1. Discussion and Possible Action on Recommendation for Construction Plans for Danamere Farms – Plat 8

RE: **Danamere Farms Plat 8 – Construction Plan Review**
Carlisle, Iowa
FOX Ref No: 8666-03C.258

FOX Engineering has completed the second review for of the Danamere Farms Plat 8 Construction Plans, dated June 11, 2020 and offer the following comments:

DANAMERE FARMS PLAT 8 CONSTRUCTION DRAWINGS

LANDSCAPE PLAN

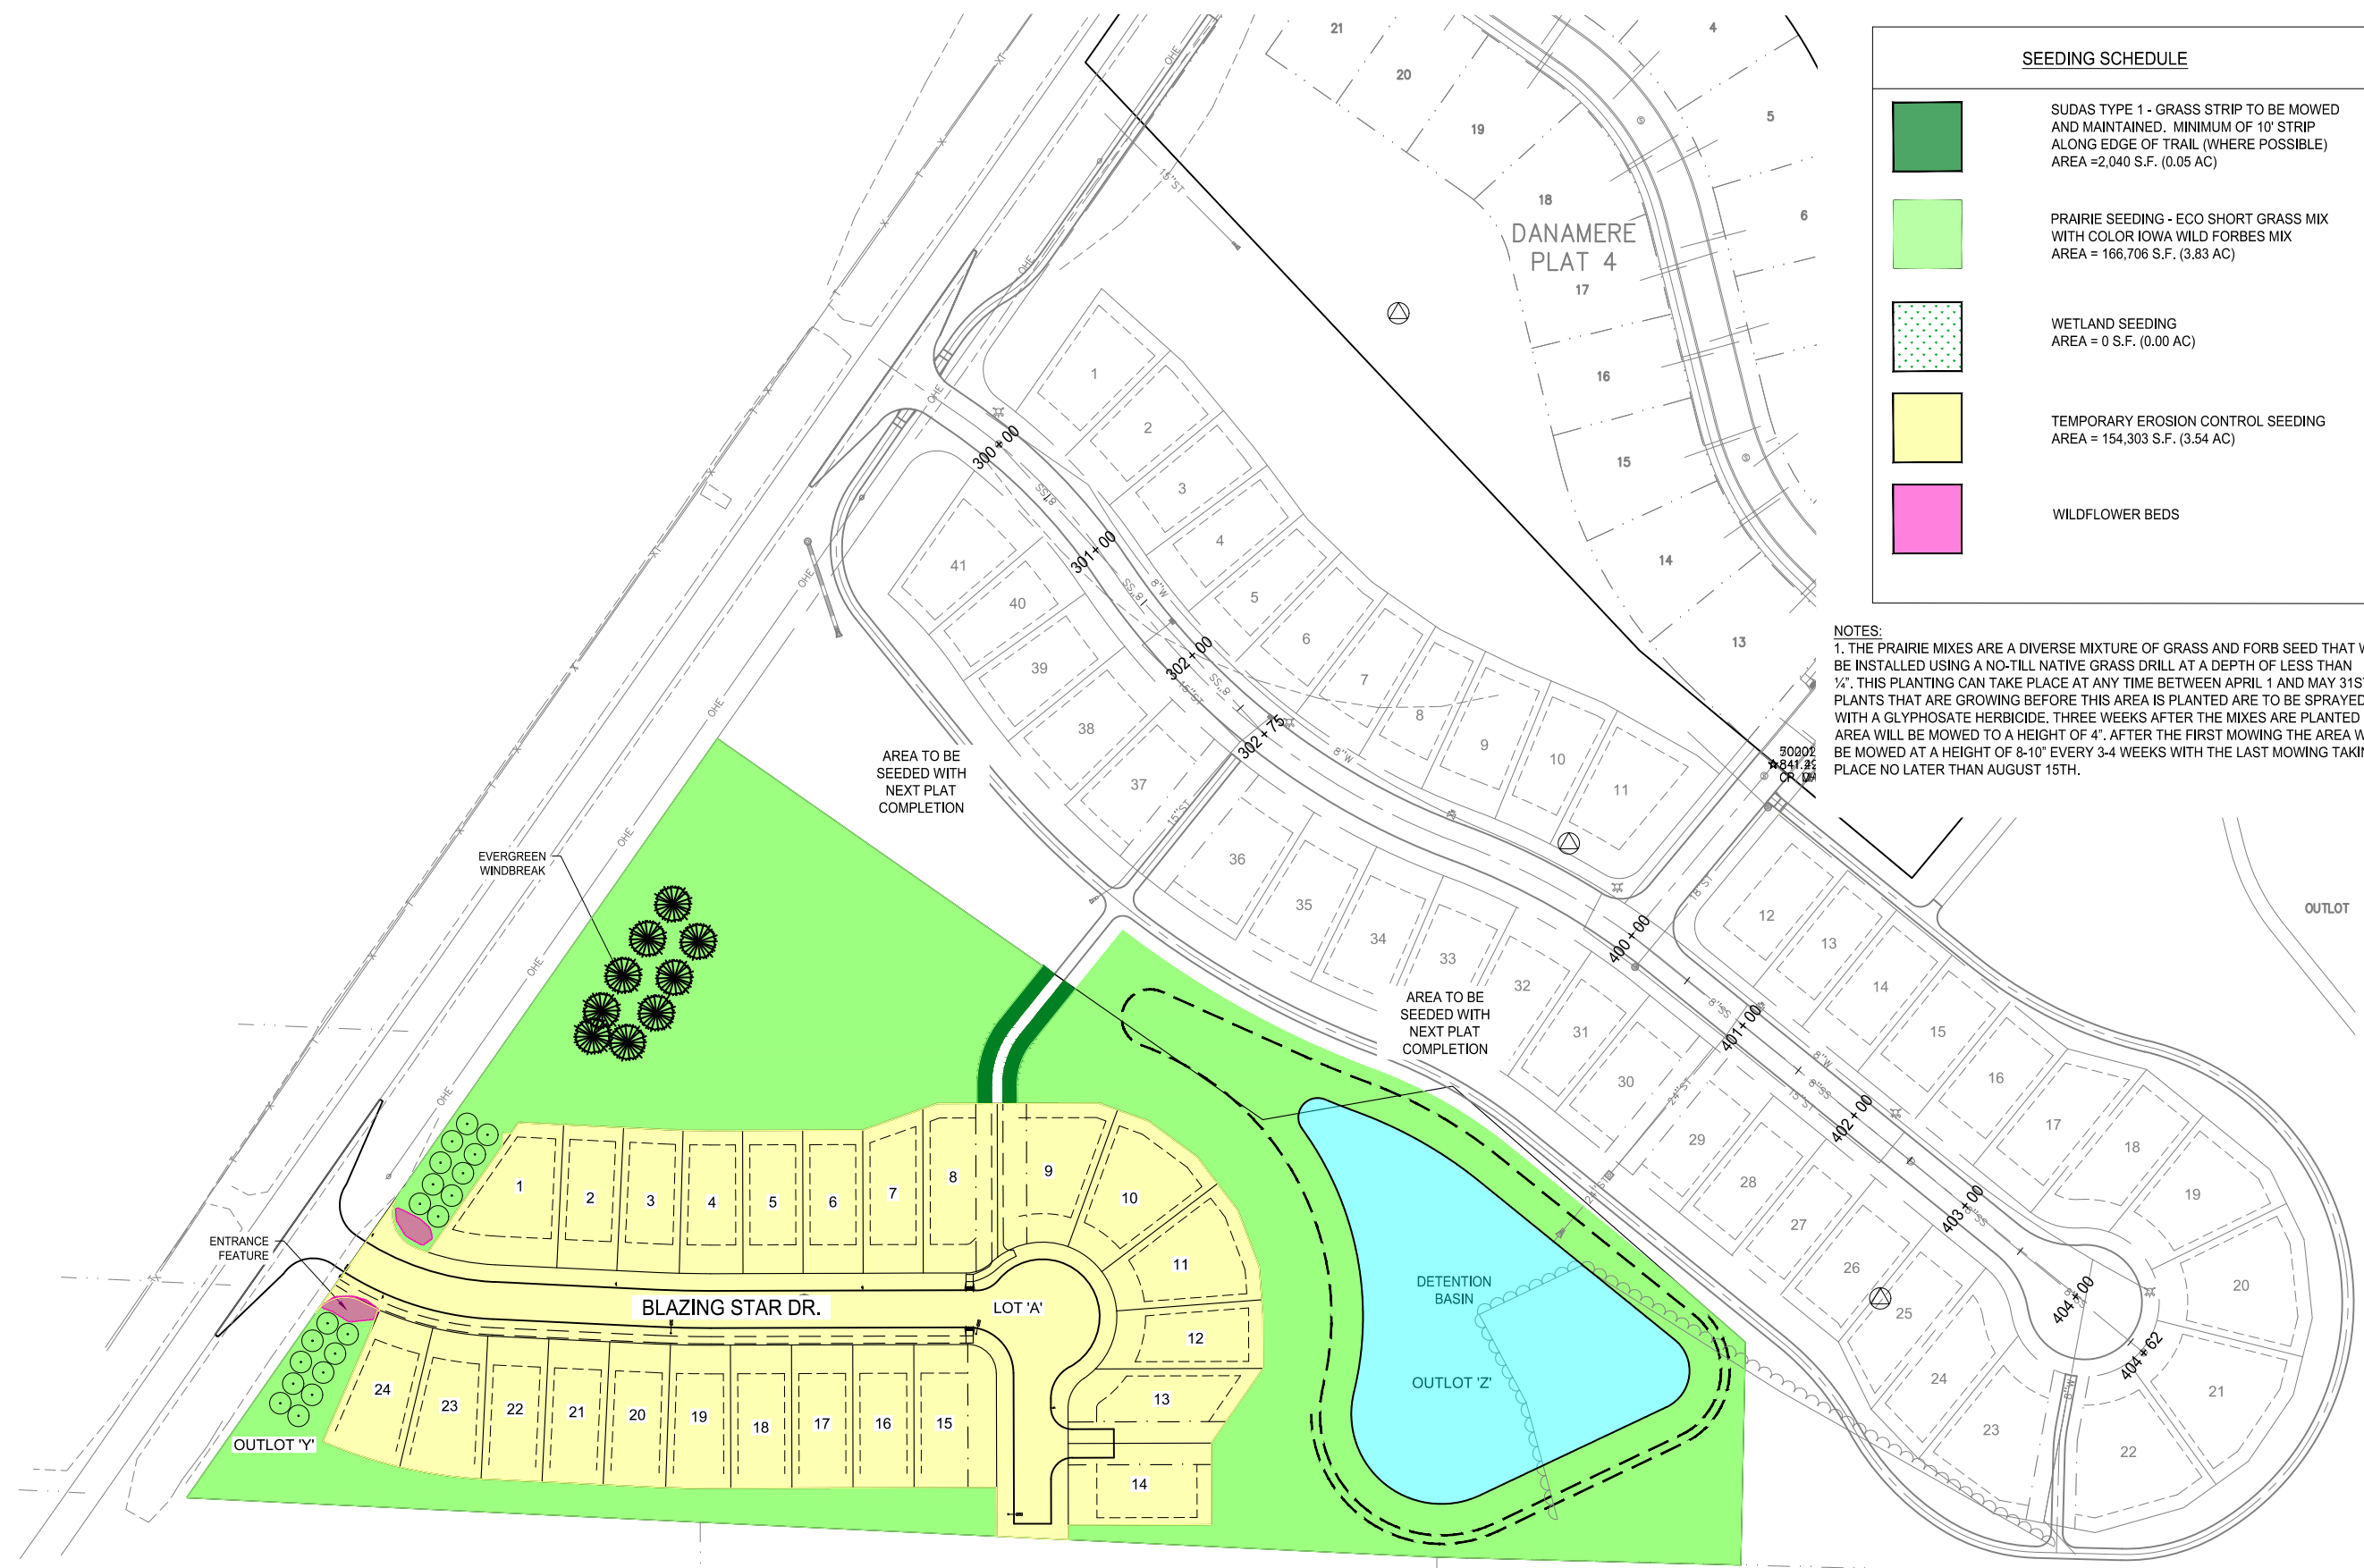
Landscape Plan

11. The Evergreen windbreak and entrance feature shown on the Landscaping plan matches what was provided as part of the approved Danamere PUD amendment.
12. Please indicate seed type for disturbed area associated with installing sanitary sewer outside this plat.
